Date: May 4, 2004
 To: T10 Technical Committee
 From: Alvin Cox (alvin.cox@seagate.com), Mike Jenkins (jenkins@lsil.com)
 Subject: SAS TCF update

5.3.11 Transmitter characteristics

Figure 53 — ISI loss example at 3,0 Gbps

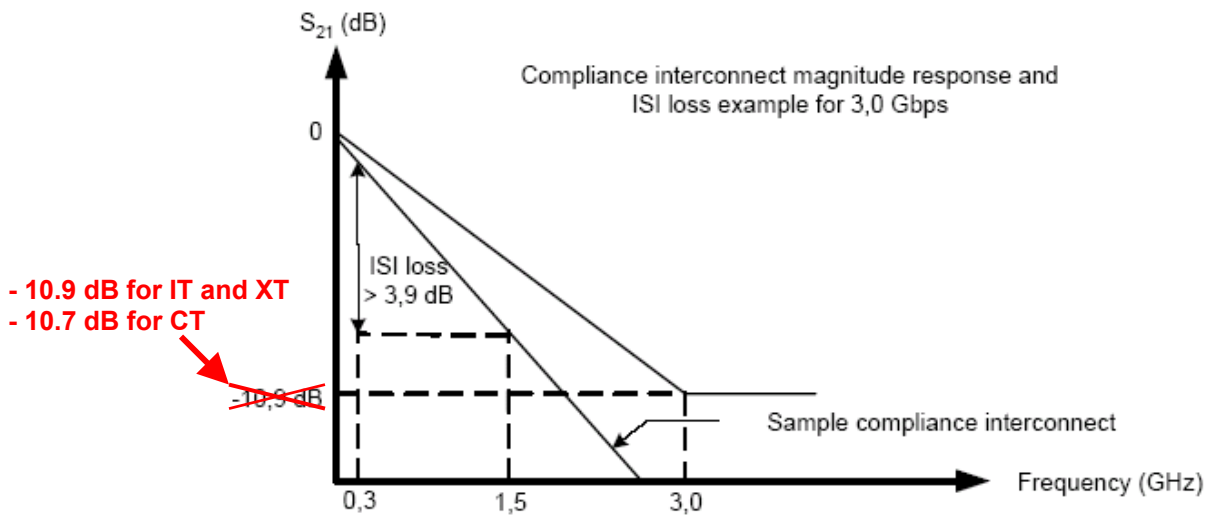
Revise the text and figures as indicated below:

The TCTF is used to specify the requirements on transmitters that may or may not incorporate pre-emphasis or other forms of compensation. A compliance interconnect is any physical interconnect with loss equal to or greater than that of the TCTF at the above frequencies that also meets the ISI loss requirements shown in figure 53 and figure 54. Transmitters compliant to the CT requirements are also deemed compliant to the IT and XT requirements.

Figure 54 — ISI loss example at 1,5 Gbps

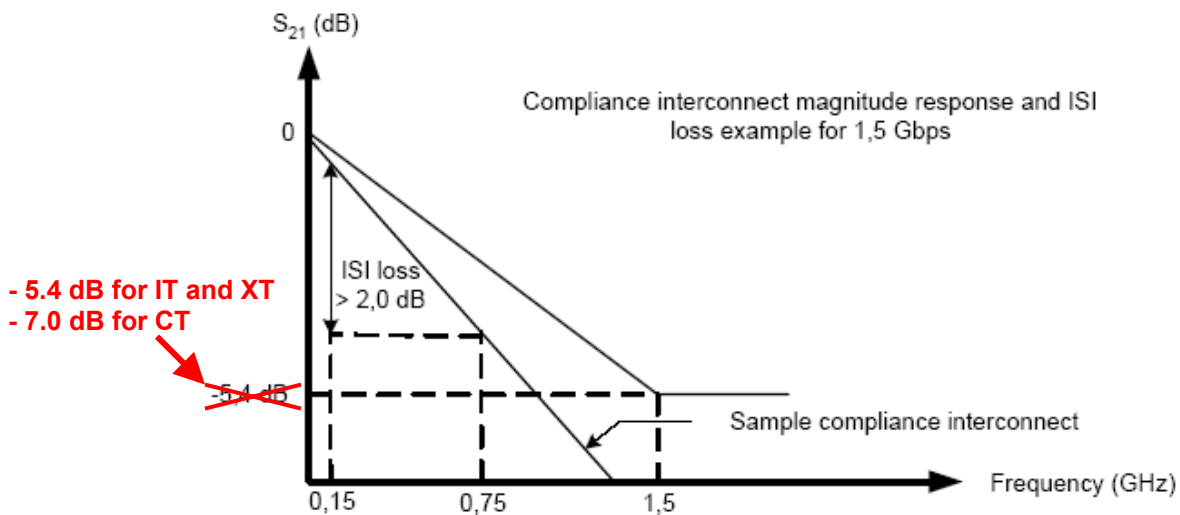
Figure 54 shows an ISI loss example at 1,5 Gbps.
